International Aero Engines
SERVICE BULLETIN

Subject: Transmittal of Revision 2 to Service Bulletin V2500-ENG-71-0182.

POWER PLANT - EEC CHANNEL-A AND B HARNESSSES (LOOM A AND B) - INTRODUCTION OF
REVISED ENGINE DEDICATED ALTERNATOR CONNECTORS

V2500-ENG-71-0182

Schematic view - Clip Position CP2346 - Before and after alteration
Figure 10

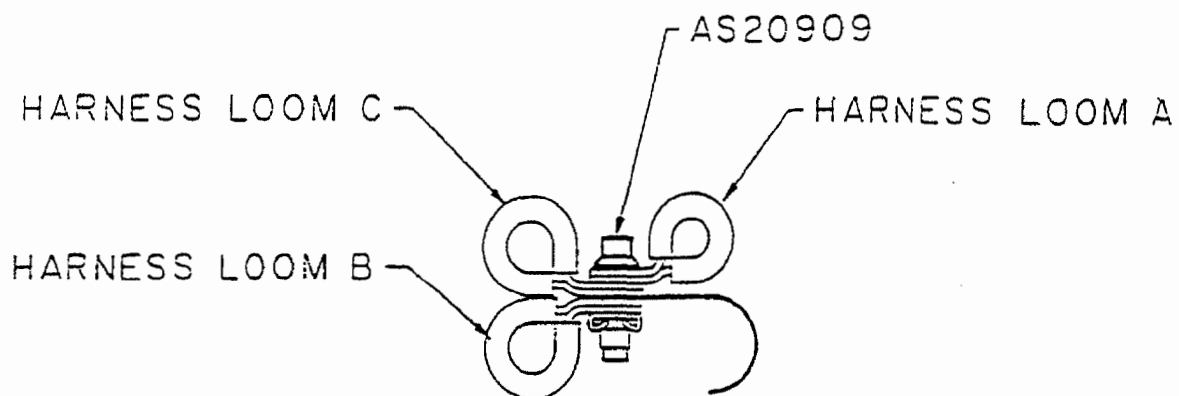
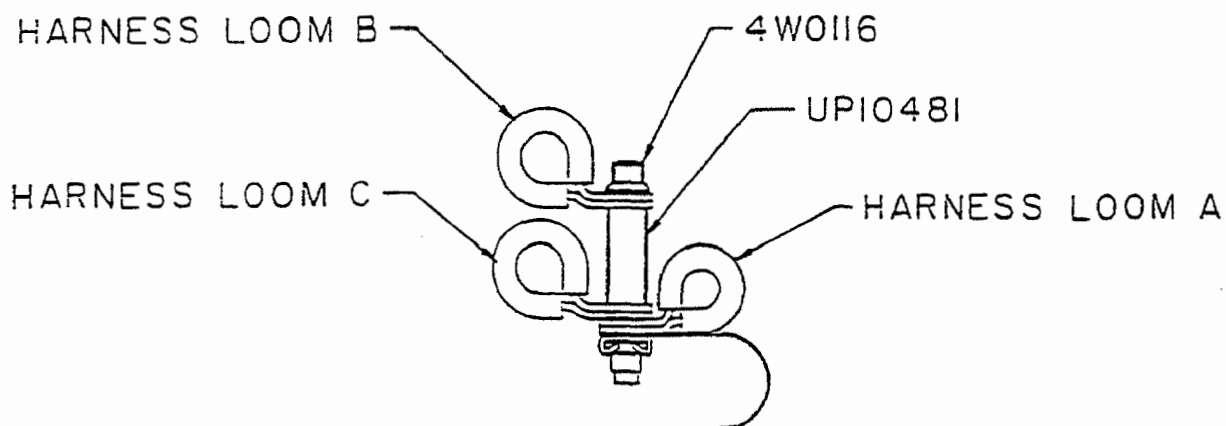
- (g) With the clip removed at (d) and a 20,0 mm spacer, install Loom-B at CP2346.

Torque load the nuts between 36 and 45 lbf.in. (4,0 and 5,0 Nm). (Refer to Figure 10).

View from BDC - Install the loop on the fire wire harness.
Figure 11

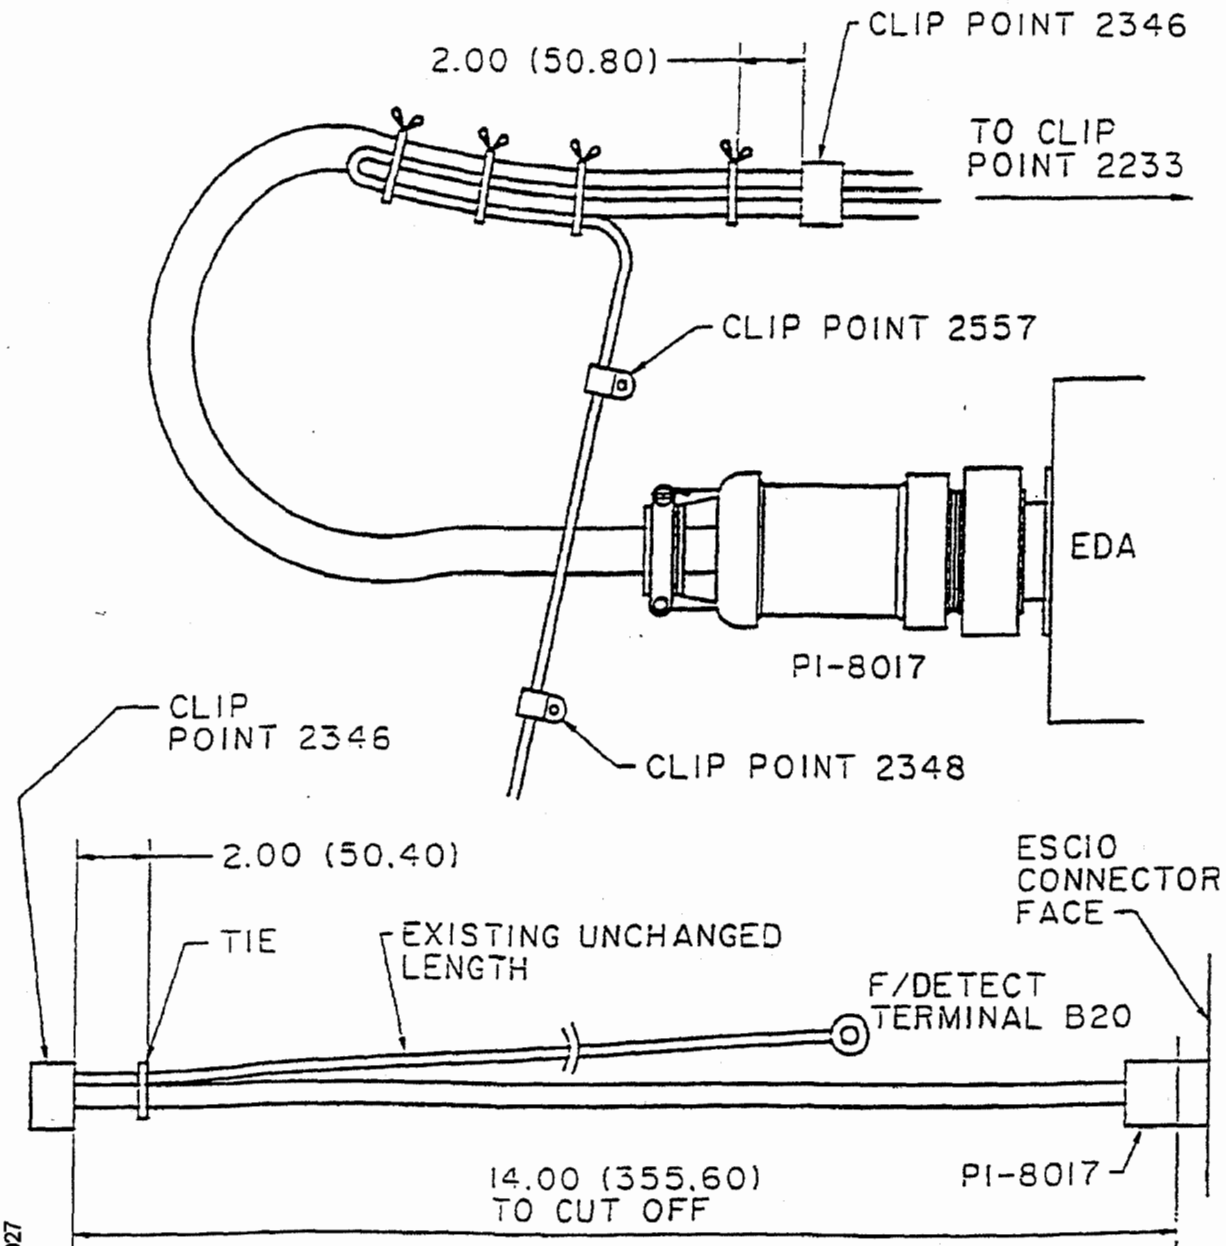
- R (v) Because of the re-routing of Loom-B, the excess length of the fire-wire harness is tied
R back to the main harness 2 in. from the clip position CP2346. (Refer to Figure 11).

- R (v) Because of the re-routing of Loom-B, the excess length of the fire-wire harness is tied
R back to the main harness 2 in. from the clip position CP2346. (Refer to Figure 11).

R
R
R | (o) To remove the unwanted length of cable, (Approximately 10.0 in. (254 mm)) make a loop with the fire wire harness from CP2557 to CP2346. | Make sure that the bends of the loop are not less than 5 times the diameter of the wire. (Refer to Figure 11). |
